THE GODDARD SCHOOL

JSP19-33

Consideration at the request of PEA, Inc., for Preliminary Site Plan and Stormwater Management Plan approval. The subject property is located in Section 12 south of Thirteen Mile Road and west of Cabot Drive, and is zoned OST, Office Service Technology. The applicant is proposing to construct a 10,957 square foot building, fenced outdoor recreation areas and associated parking for a child day care center.

PLAN REVIEW CENTER REPORT

L-1.0

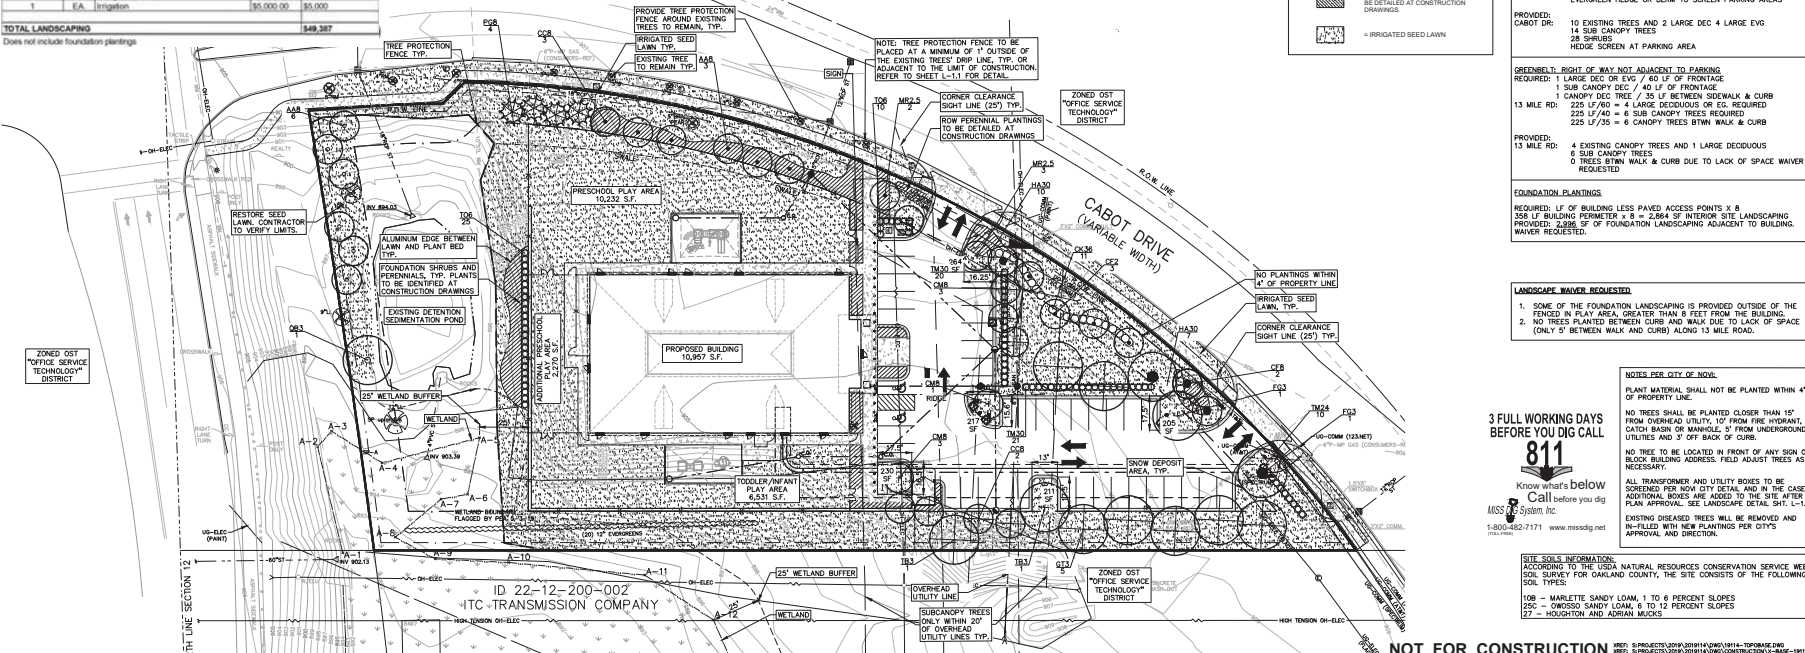
1. Provided
2. Please provide protection for the line of evergreens on the west side of the property.

- provided.
2. The required 4 canopy and 6 subcanopy trees are provided along 13 Mile Road.
 3. **Two more canopy or large evergreen trees are required along Cabot Drive. A landscape waiver would be required to not provide them.** *This is not supported by staff.*

As noted above, the Plan does not include impacts to wetlands. The Plan does however propose grading within the 25-foot setback of Wetland A as well as the 25-foot (watercourse) setback of the existing stormwater detention basin. The impact to the 25-foot setback of Wetland A is quantified on the *Grading Plan* (Sheet C-3.0). The proposed buffer disturbance is indicated as approximately 1,720 square feet (+/- 0.039-acre). This impact appears to be a permanent impact for grading and will be stabilized with lawn seed mix as opposed to a native wetland buffer or prairie seed mix as indicated on the *Landscape Plan* (Sheet L-1.0).

Figure 1. City of Novi Regulated Wetland & Woodland Map (approximate property boundary is shown in red). Regulated Woodland areas are shown in green and Regulated Wetland areas are shown in blue.

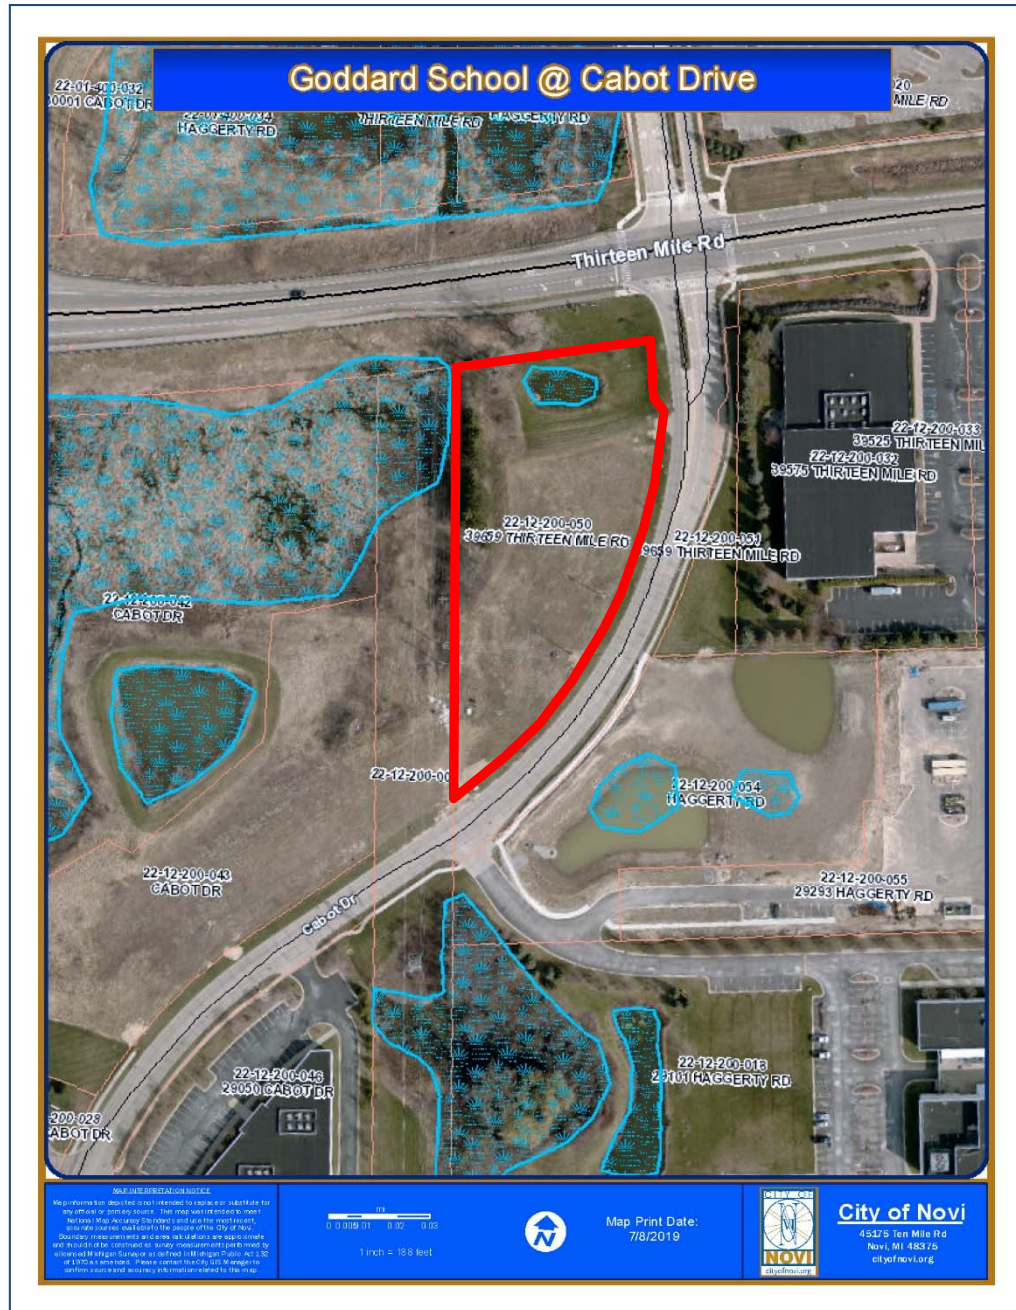
Based on our review of the application, Novi aerial photos, Novi GIS, the City of Novi Official Wetlands and Woodlands Maps (see Figure 1, attached), and our site inspection, it appears as if the overall project property contains City-Regulated Wetlands. The proposed limits of disturbance contains 25-foot wetland setback area but does not contain wetlands.
